**PLANNING & ZONING BOARD
AGENDA ITEM 6A**

**PLANNING & ZONING BOARD
AGENDA ITEM 6B**

TOPIC: **PUBLIC HEARING** for Lino Lakes Dealership and Offices
1. Conditional Use Permit
2. Site and Building Plan Review

CASE NUMBER: CU2025-0001
SP2025-0005

SITE PLAN
7920 LAKE DRIVE

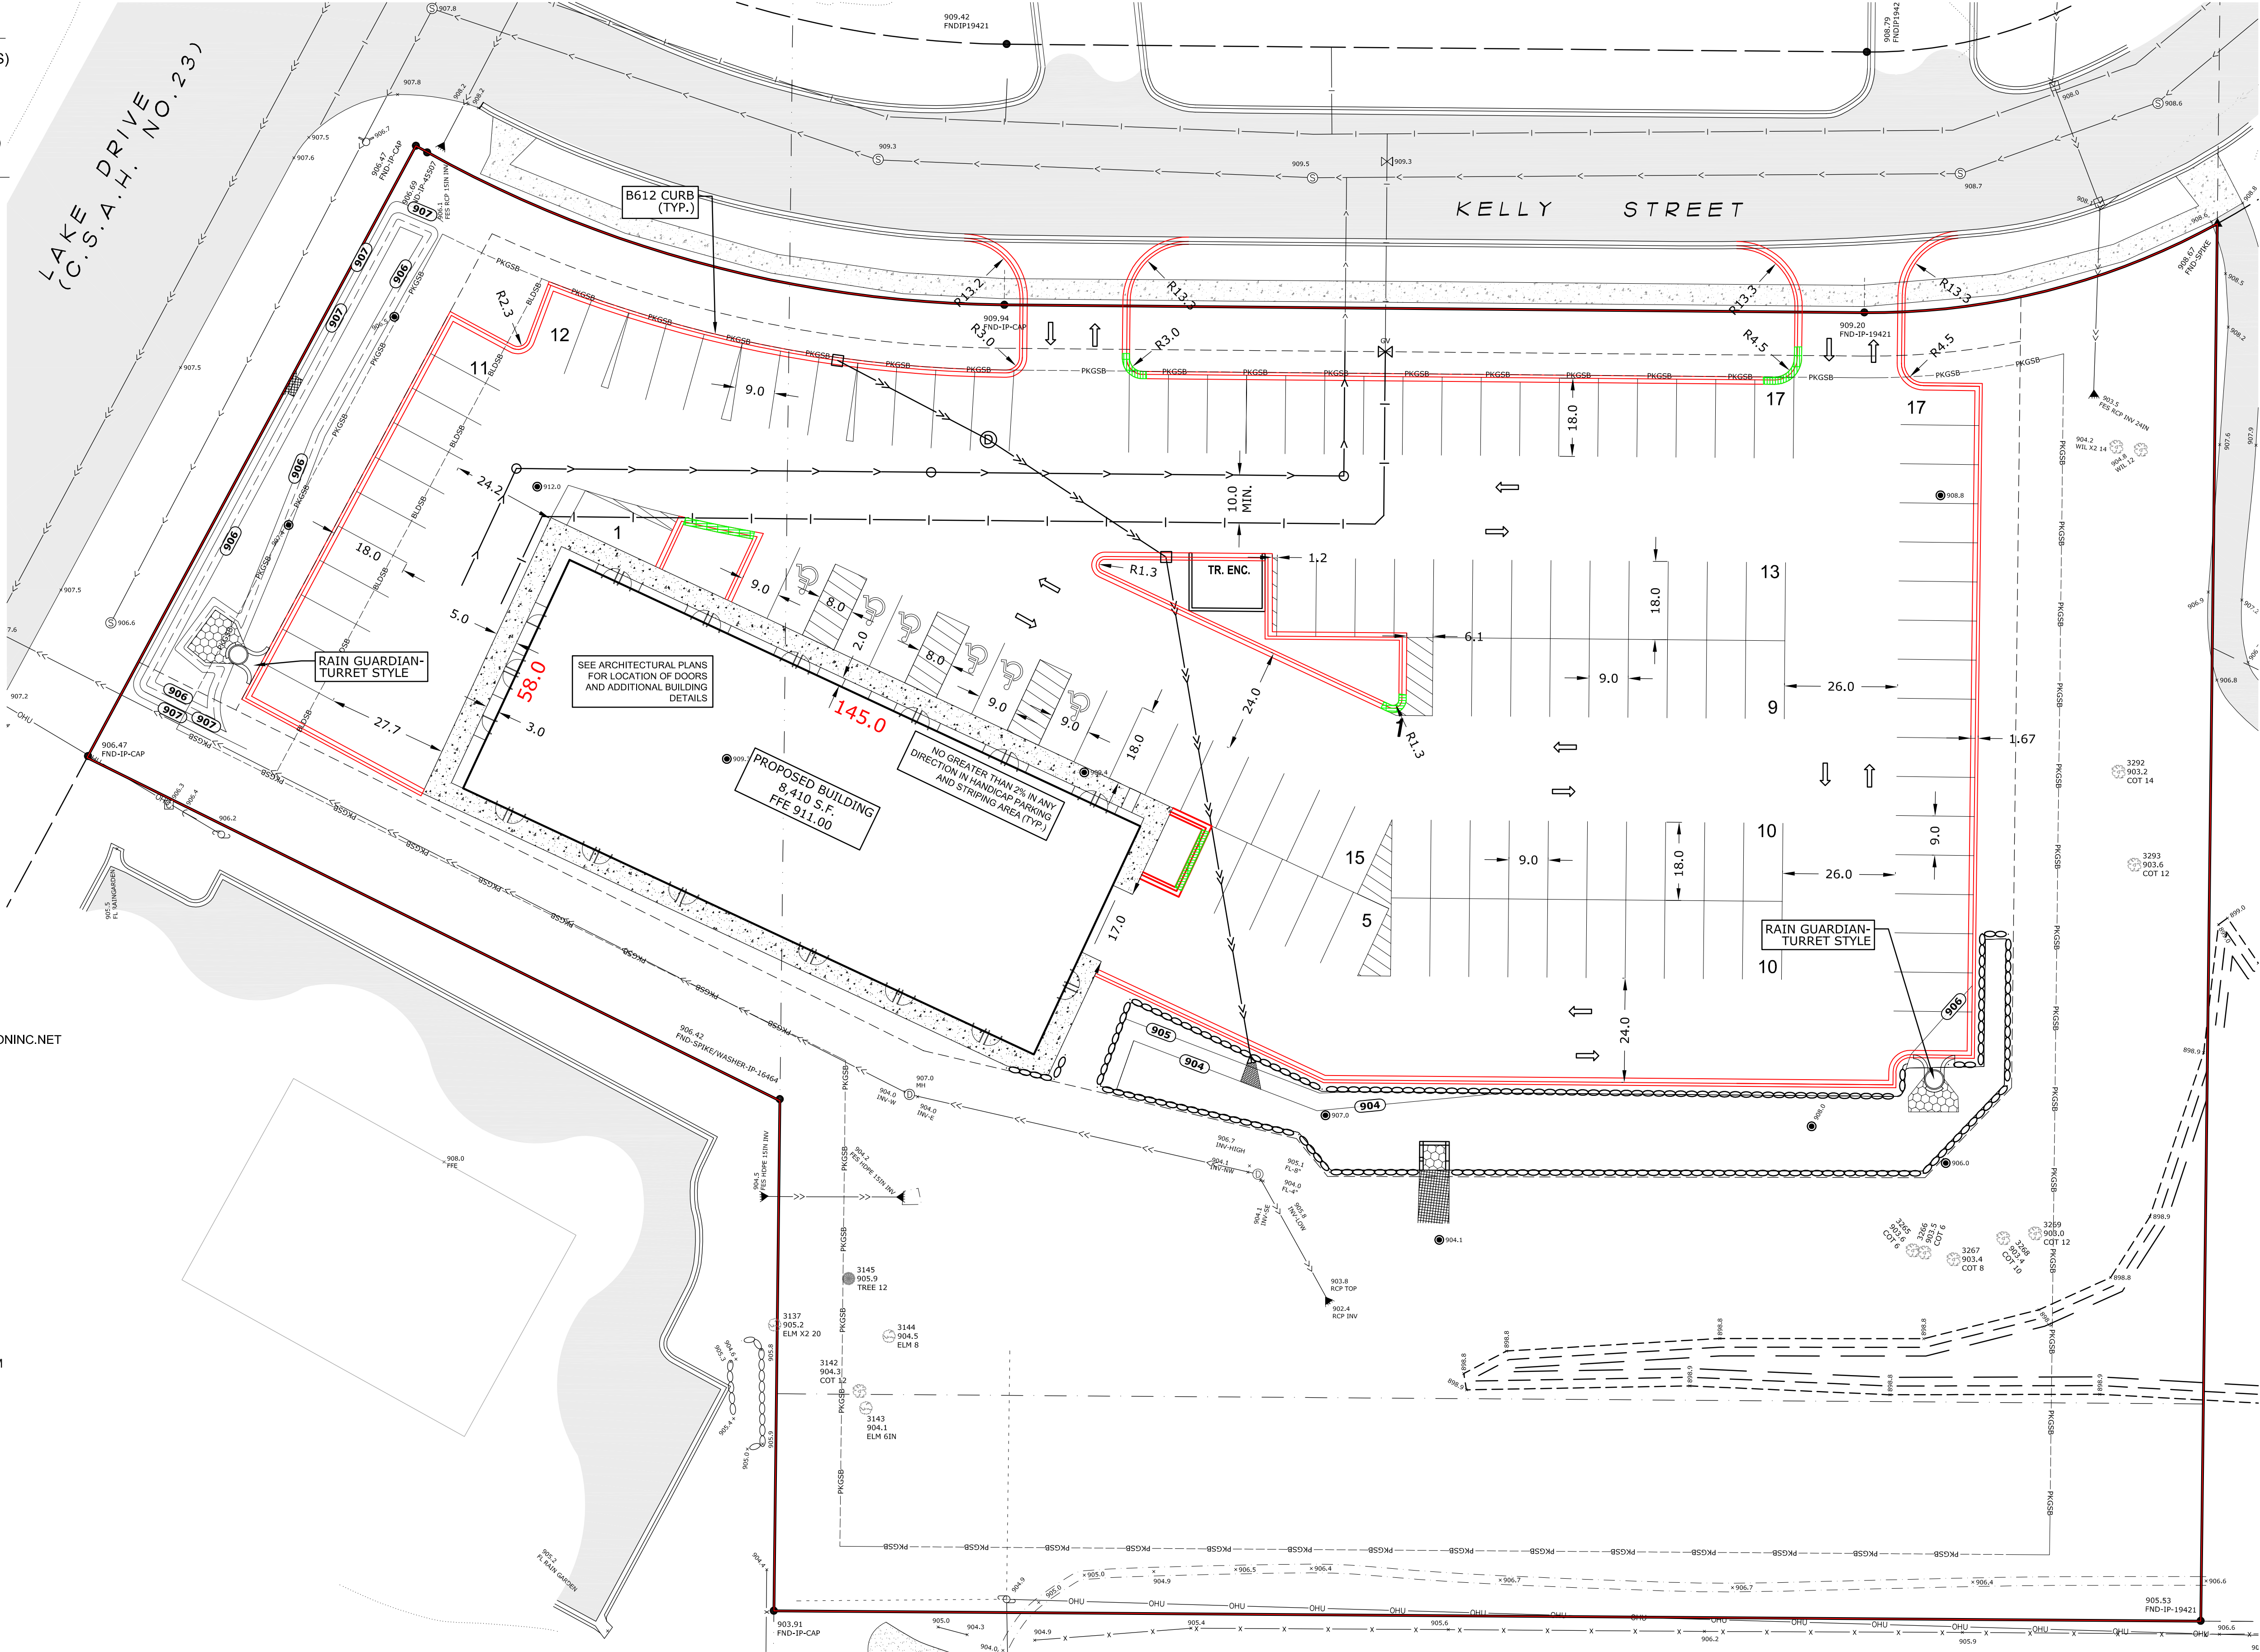
7. The building sf shall be the same on all applicable plan sheets.
 - a. For example, Sheet C1 notes 8,410sf but Sheet EX01 notes 8,010sf.
8. Sheet C1, Site Plan:

- c. Verify that all exterior doors meet ADA clearance requirements.
9. Sheet EX01, Conceptual Site Plan:
 - a. A scale bar shall be added to the sheet.

LINO LAKES DEALERSHIP + OFFICE
LINO LAKES, MINNESOTA
GRADING, DRAINAGE, AND EROSION CONTROL PLAN

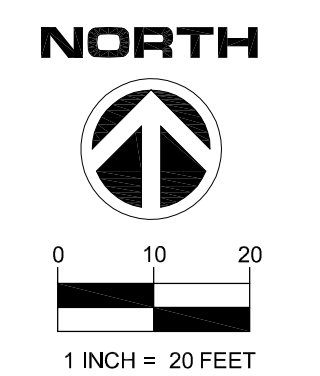
1. Remove basin (INF-2) from drainage and utility easement
2. Provide Emergency Overflow (EOF) elevations for all low points in the parking or green space areas.
3. Provide 15' trail easement
 - a. Grade for future trail

4. Address conflict between FES/storm sewer and retaining wall
 - a. Provide detail
5. Provide retaining wall details
 - a. Retaining Walls greater than 4' would require a City permit and be designed by a structural engineer
6. Verify whether CBMH 1 or CBMH 3 can be shifted to eliminate CB(ST)MH 2
7. Additional redlines on the plans to be addressed

1. The proposed parking lot grading must be revised to raise it above the regional pond HWL of 906.53.
2. CBMH 3 needs a sump to provide pretreatment of inflows to INF-1.

9. Revise storm sewer to collect more of the surface flow from the eastern half of the parking area.
 - a. Currently all surface flow goes to the southeast curb cut

LINO LAKES DEALERSHIP +
OFFICE
LINO LAKES, MINNESOTA
UTILITY PLAN

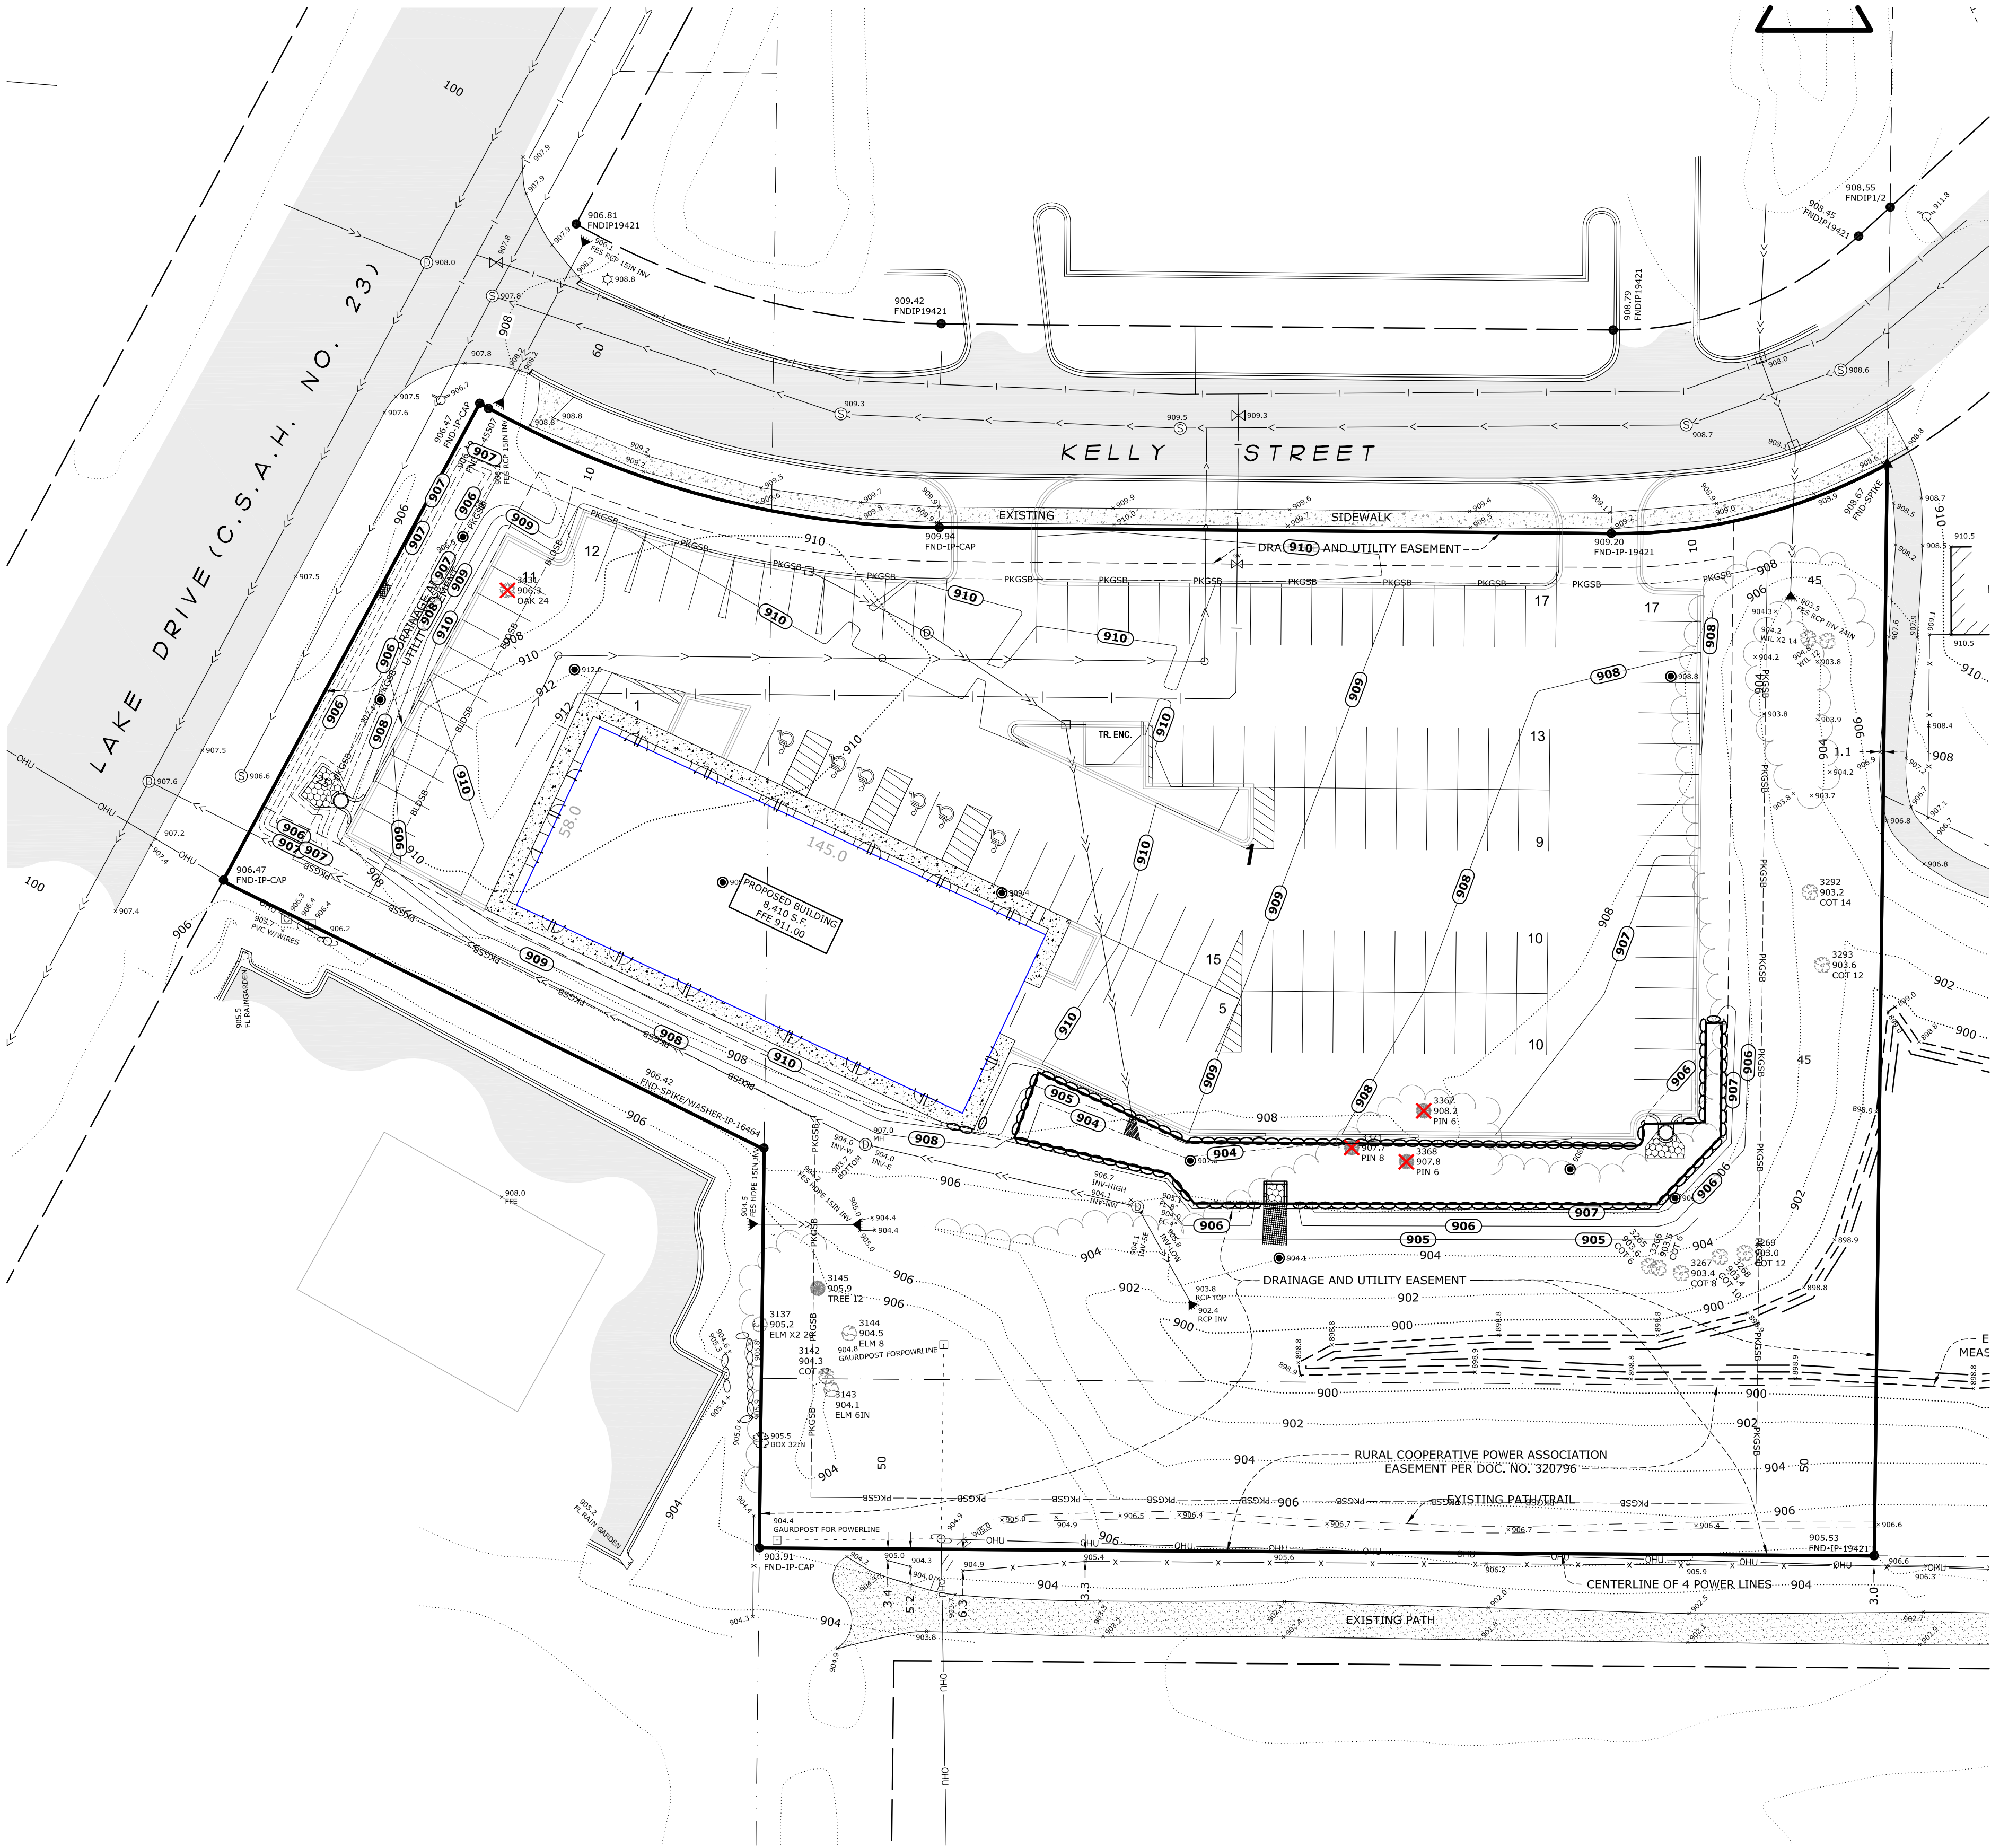
1. Show approximate location where existing utilities enter the building.
2. We recommend that the City Deputy Director of Public Safety-Fire Division review the proposed plan for water supply and hydrant coverage.

3. Verify need for separate fire and domestic services with separate shutoffs
4. Additional redlines on the plans to be addressed

1. Show approximate location and elevation where existing utilities enter the building.
2. Additional redlines on the plans to be addressed
